# SERVICE BULLETIN

ISSUE DATE: 7/90 MODEL: 2CM, 2.5CM,  
REVISION DATE: - 2.5CMZ

SUBJECT: LP Gas Fuel  
Leakage

NO.: 500

Figure 1. Carburetor Fuel Hose Connections

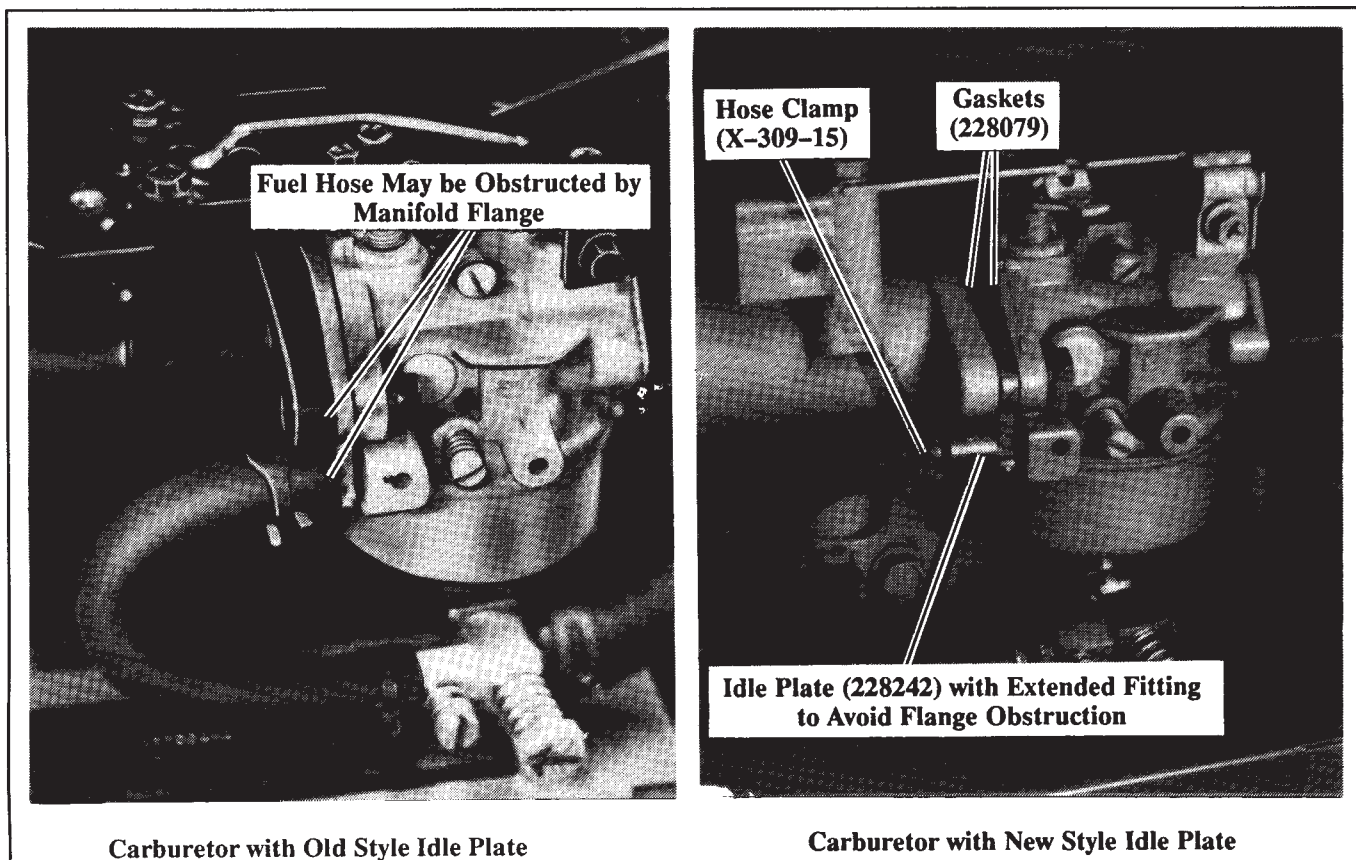
On LP-fueled 2CM, 2.5CM and 2.5CMZ-RV generator sets the fuel hose may be improperly positioned on the carburetor idle plate fitting and fuel leakage may occur. If the fuel hose is obstructed by the intake manifold flange casting, the fuel hose may not slide completely over the idle plate fitting. See Figure 1. If the fuel hose is not fully-seated on the idle plate fitting, install a new idle plate (228242) and hose clamp (X-309-15). The new idle plate is manufactured with an extended hose fitting to avoid the manifold obstruction and insure a secure fuel hose connection. The two carburetor gaskets (228079) may be damaged during disassembly and should also be replaced. A flat rate of one-half hour has been established for this change. (Submit a Warranty Claim (KO-1500) referencing this service bulletin.) The hose clamp, gaskets, and new idle plate are available from generator service parts.
